**WORTHING BOROUGH
COUNCIL**

**Planning Committee
26th June 2019**

Report by the Director for Economy

Planning Applications

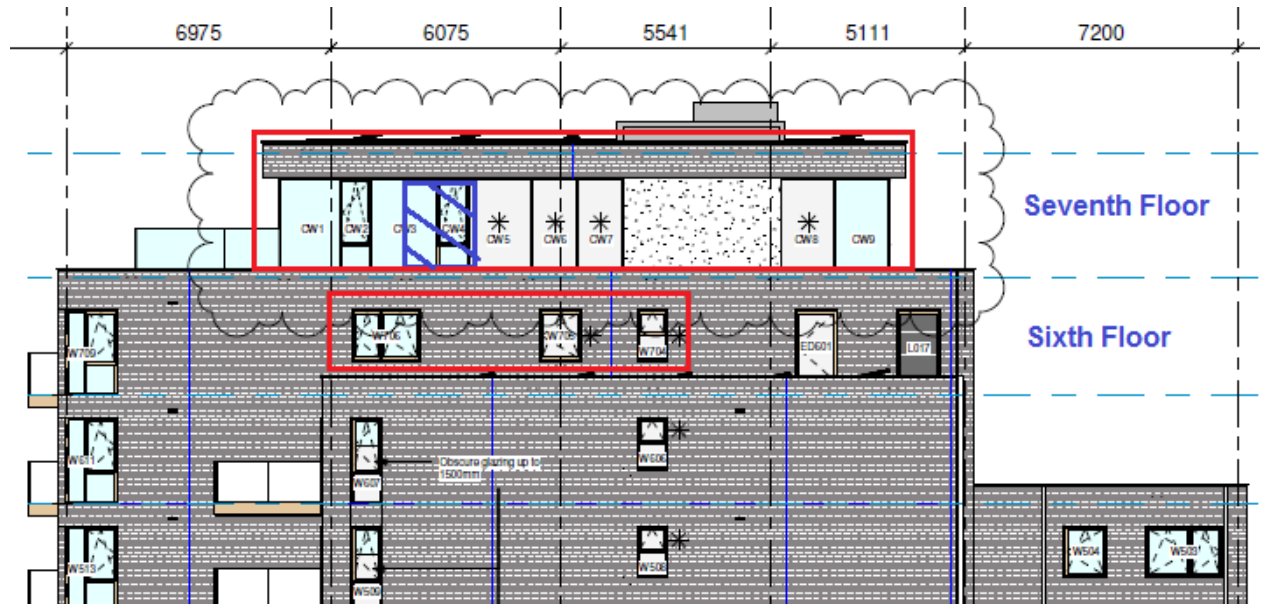
- 3.5. Neighbouring residents express concern that the lack of screens will demonstrably impact their privacy. It is noted that their balconies are approximately 1.7 deep and just accord with contemporary external space standards of the SPD. They are an important area of outdoor amenity space.
- 3.6. In consideration of these views, it is noted that the absence of balcony screens from the closest of the approved balconies, which are some 2.8m deep, would provide a direct line of sight to those of Regis Court. Whilst the intervening corner of the approved building may block the line of sight from part of each balcony (perhaps the closest 0.8m to the building façade), the remainder would be unobstructed.

- 3.7. Although a similar relationship to that proposed in the current application, exists between balconies on the east side of Regis Court and four of the balconies at its neighbouring block (Capelia House), this is not typical of the relationships between balconies of tall seafront buildings further east. Others are set further apart or are screened. Furthermore this limited comparable relationship pre-dates the Council's Supplementary Planning Guidance, which sets out the importance of privacy for balconies. The existing balconies to Regis Court are set some 32m from the site frontage, and although they face towards a well-used promenade, the distance affords a degree of privacy, which merits protection.

- 3.8. Officers have suggested compromise solution to the applicant, whereby the 1.6m obscure screen, such as frosted glass, would only run along half of the side of each balcony, with the front corner reducing to a standard lower height of approximately 1m of clear or obscure glass. It is considered that in the ordinary course of using the balconies, looking southwards towards the sea or slightly south east towards the pier, users are unlikely to look across neighbouring balconies. In this scenario a view towards the neighbours would only be had by standing close to the front corner of the new balconies and looking slightly backwards towards Regis Court.

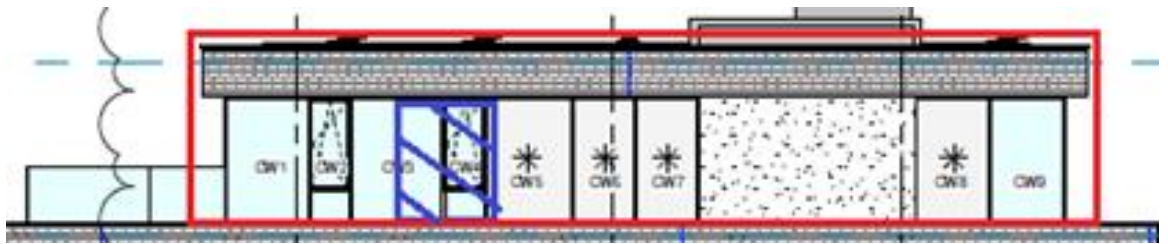
- 4.6. The window arrangement on the east elevation has been amended so that clear—glazed windows would be clustered towards each corner. Two of these would have top-hung opening sections. As the neighbour letter observes, series of opaque panels (CW5 – CW8) and wall would occupy the central part of the eastern wall.

- 4.7. These amendments have improved the impact of application, by reducing the amount of clear glazing in the central part of the side of the penthouse. However, concerns remain that a line of sight from the kitchen/diner area, towards the neighbour terrace approximately 1 floor below and 14.5m away, and in line with the southern end of the terrace, would impinge too greatly upon neighbouring privacy.

5. **Northern elevation**

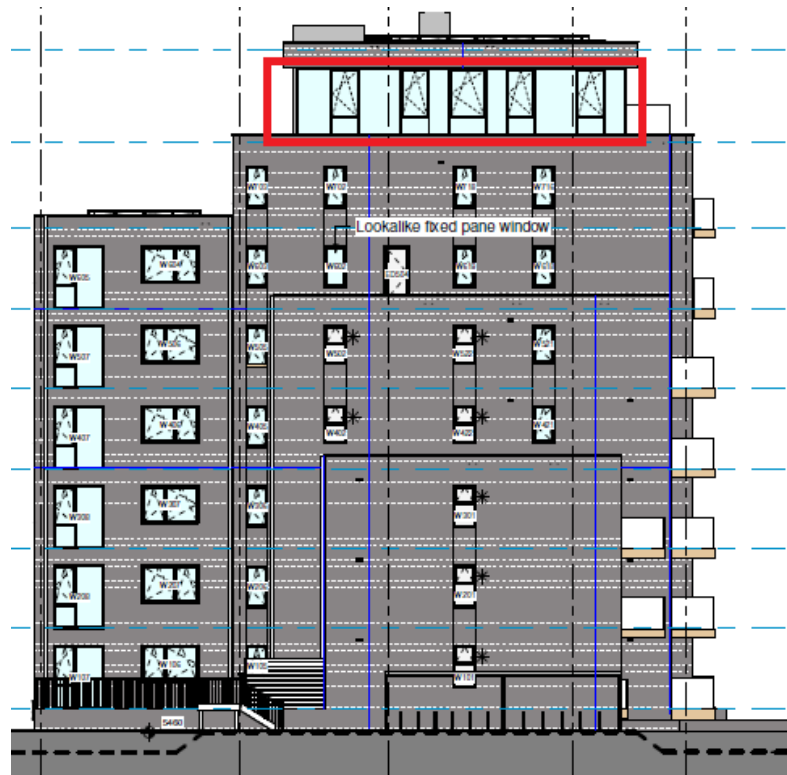
- 5.1. The proposal amends the detailed arrangement of windows on the north elevation of the penthouse, but does not change the overall amount or position of glazing here. Planning condition no 12 does not require these to be obscure glazed or unopenable. In light of this, the relocated bedroom is unlikely to significantly change the impact on neighbours to the north.
- 5.2. The amended plans continue to show the use of obscure glass to other parts of the northern elevation (see *asterisks* on the plan) as follows:
- i) all windows in the link block, which is 7m from the side boundary of the no 6 Grand Avenue, largely facing the side wall of the neighbour's house
 - ii) four windows in the 'northern shoulder' which is 21m from the boundary with no 6 Grand Avenue.
- The impact on no 6 Grand Avenue is no greater than in the approved plans.

Tower

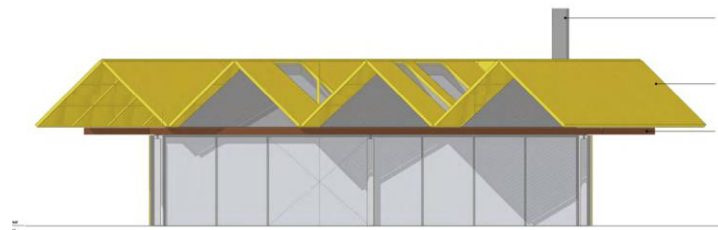
The changes to the main residential tower are more minor and relate primarily to the balcony areas and privacy screens between apartments. Where balcony dividers are introduced, these are low (1,100mm) and made of grey metal, so as to limit their visibility from the ground and in distant views.
